# Access Compliance Report

## Public Rights-of-Way

### (Curb Ramps)

Intersection ID: 7812	Main Street: SQUIRREL_HILL_RD	Cross Street: THORNWOOD_RD	Location:	N
ADA ID: 27BF207A2A84	Ramp Type: BlendTrans2	Initial Pass/Fail: Fail	Overall Compliance: No	Severity Score: 1.25
Codes/Mitigation Info/Possible Solution		Field Measurements/Component Compliance

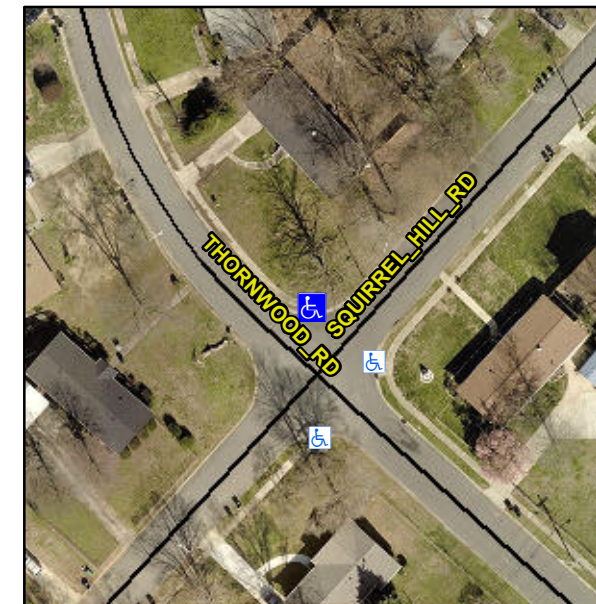
**NO RT SW**

**Not Found, R304.5.3**

**Remove & Replace Curb Ramp With Two New Directional Ramps or Equivalent.**
